# ADDENDUM No. 1

## ITB No. 4524

### 2018 Water Main and Sanitary Sewer projects

SHEET No. **17 OF 29**

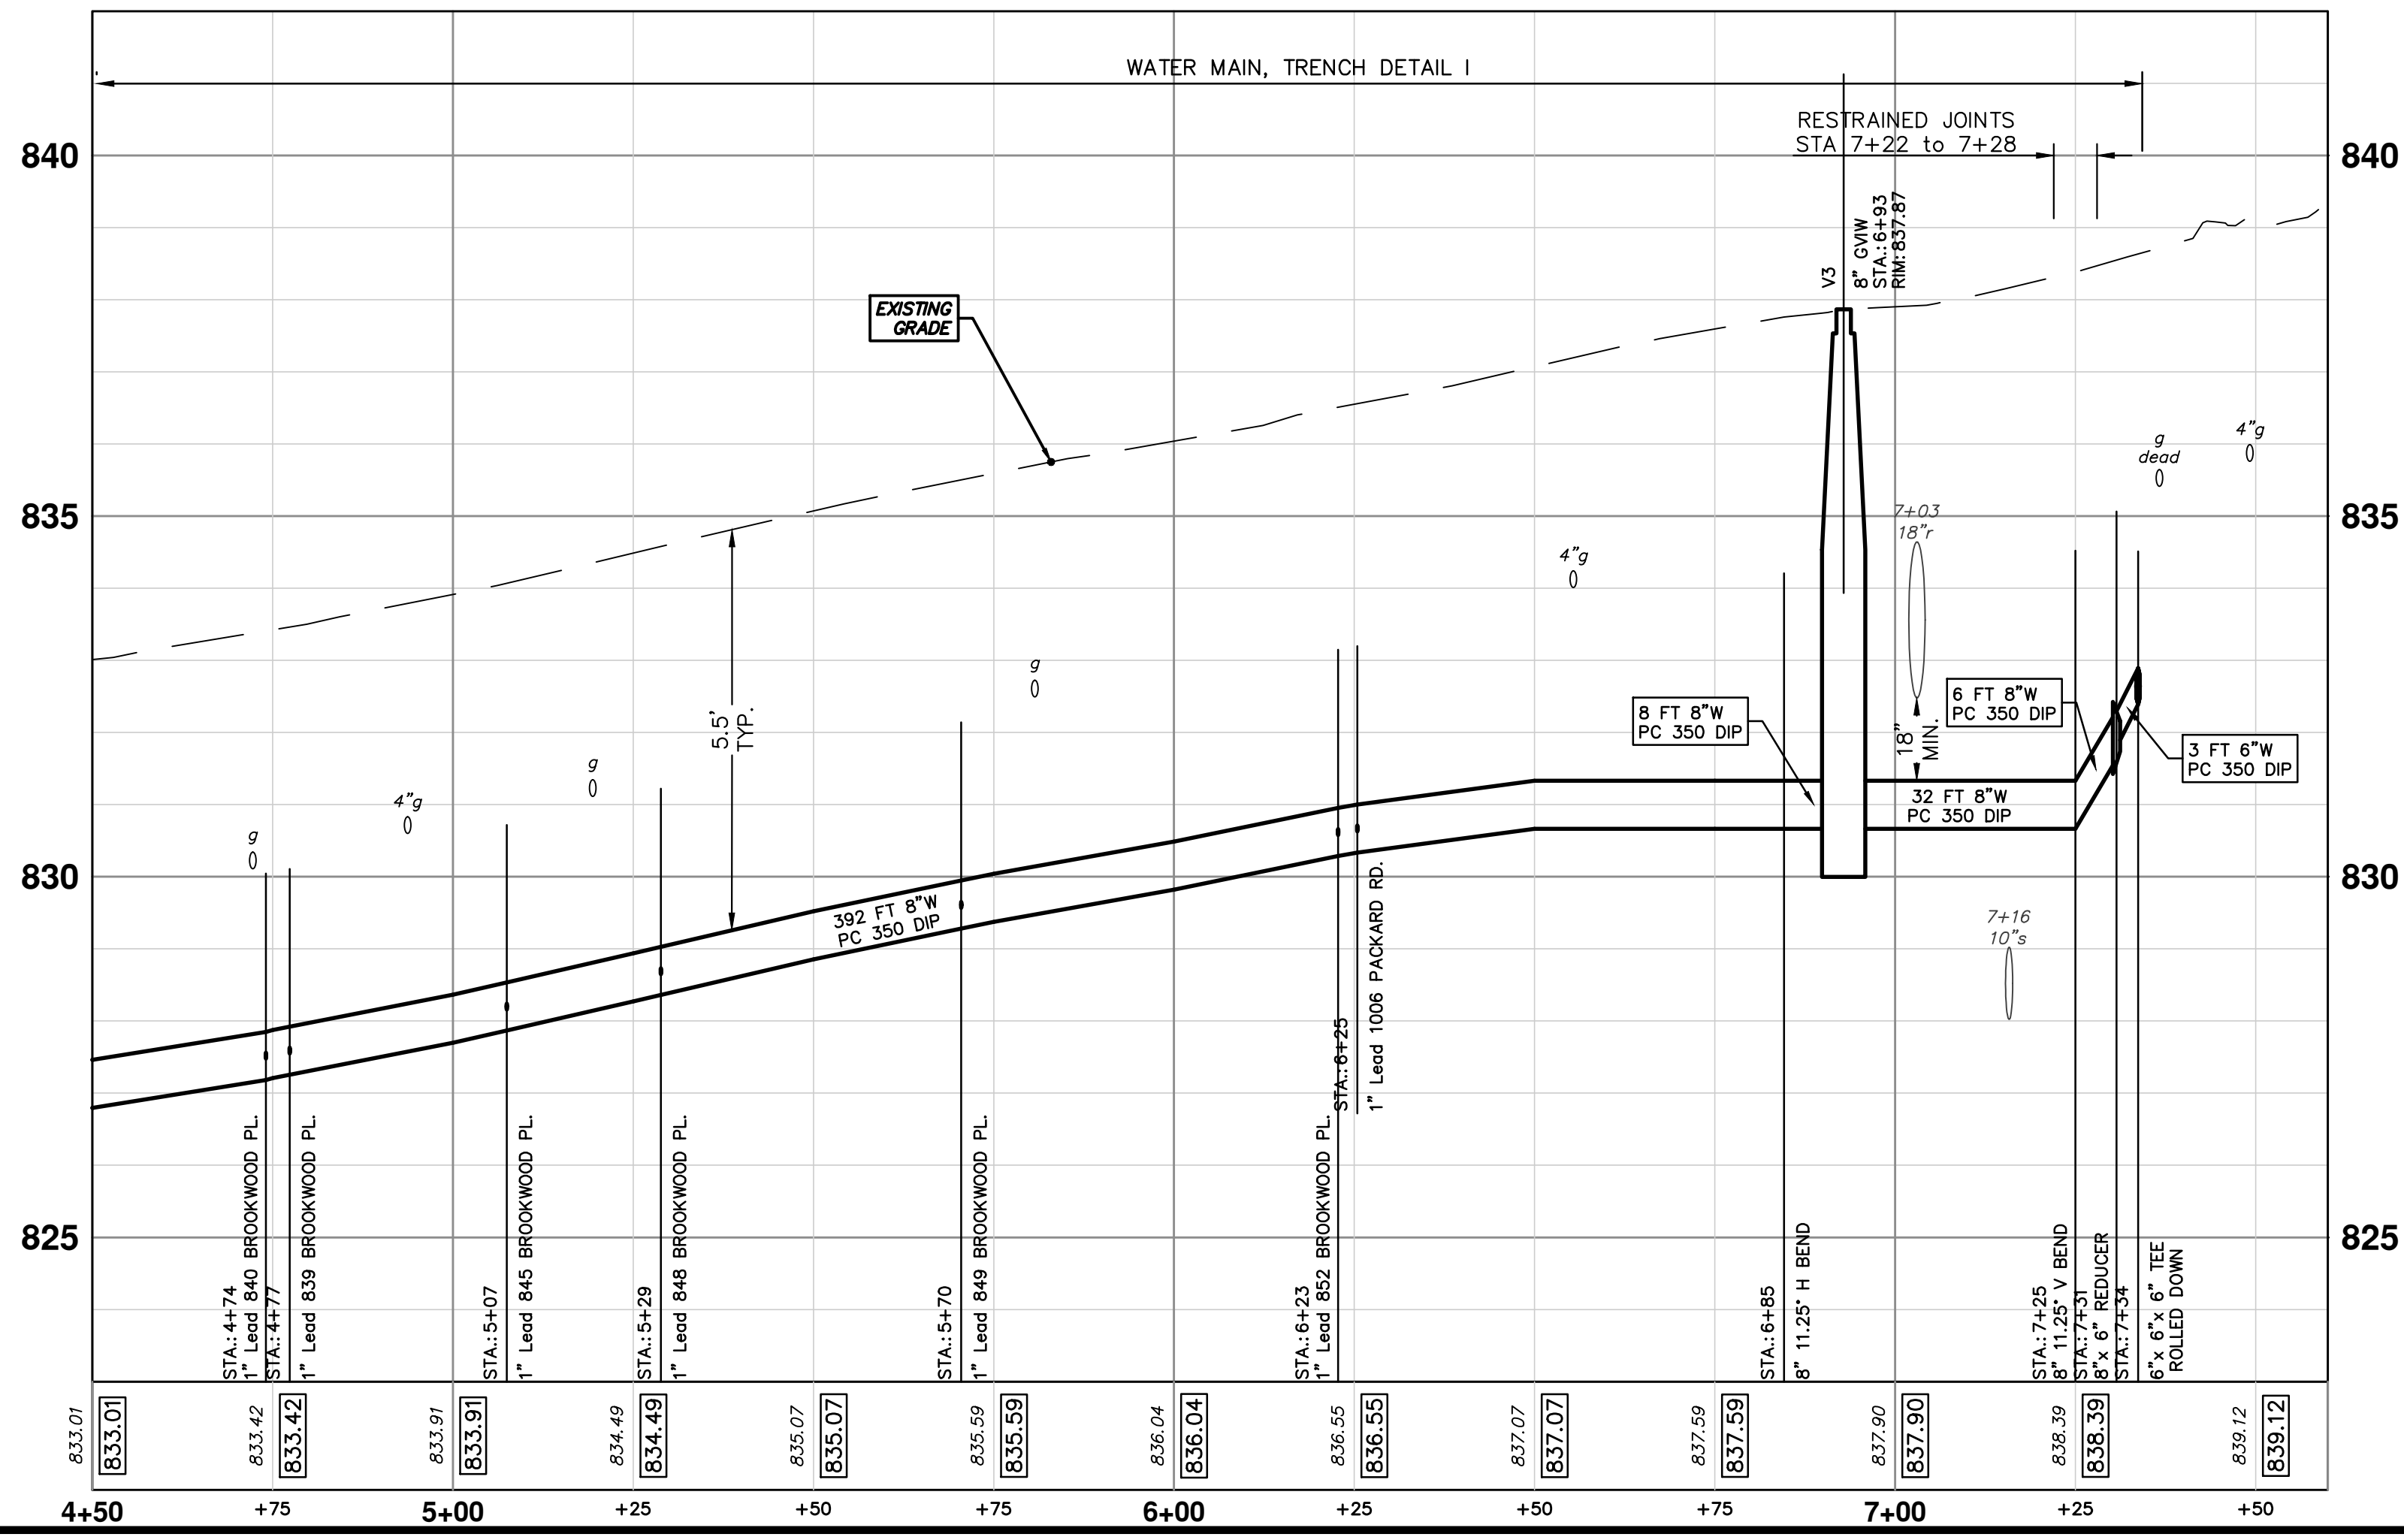
**Question 6:** Is there a rim elevation and invert for the 48" dia. sanitary manhole on sheet 17?

**Answer 6:** Approximate elevations have been added. Exploratory excavation will be required to determine verify location and elevation.

SHEET No.  
24 OF 29

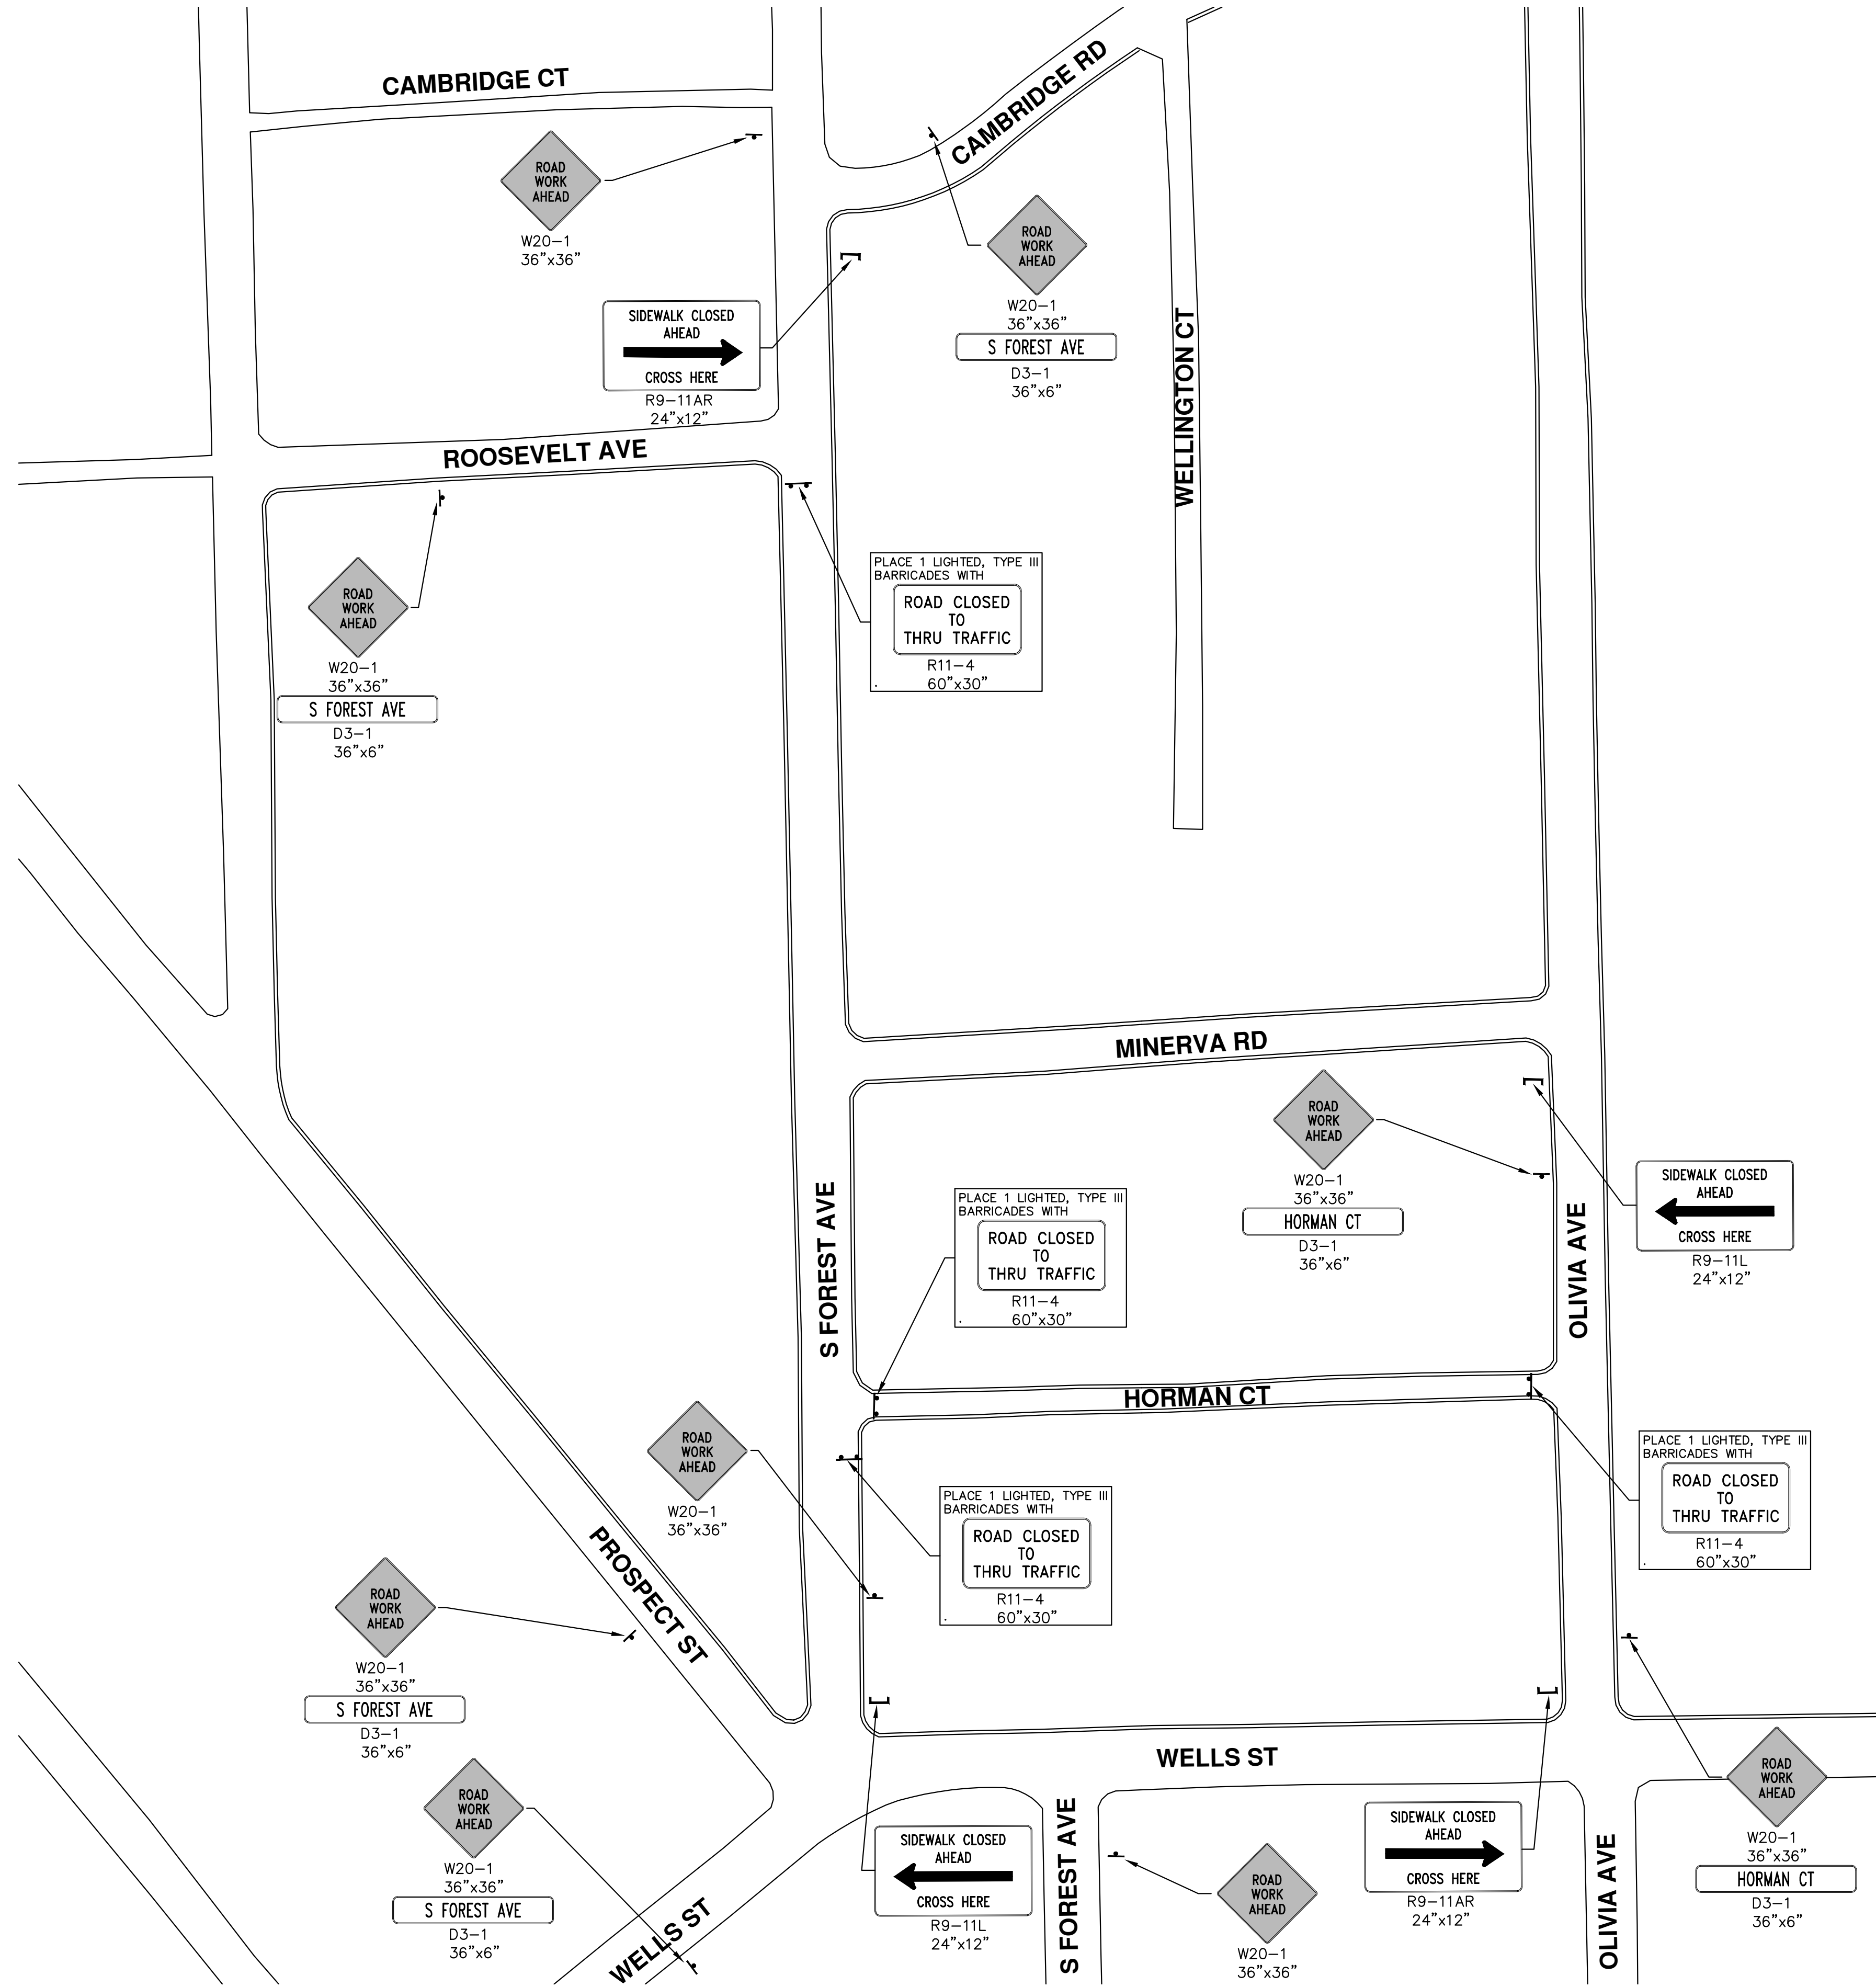
**Question 5:** Are there rim elevations and inverts for the 2' diameter structures that are shown on sheet 16, 24, 29?

**Answer 5:** The information has been added, and is included in the addendum.
